PM5357

S/UNI-622-POS

REFERENCE DESIGN ERRATA

ISSUE 2: APRIL 1999

Figure 1 - Filtering for AVD<19>

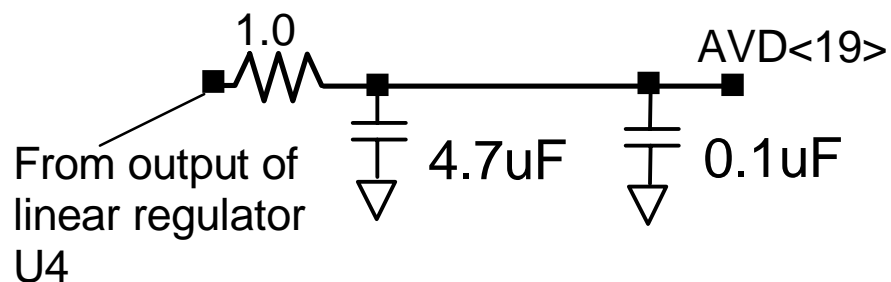
On Page 3 of the S/UNI-622-POS Reference Design schematics, Pin 19 of AVD<31..0> is tied directly to the output of the linear voltage regulator (U4). This pin should be filtered with the circuit shown below. Without this filtering, jitter performance of the device will be degraded.
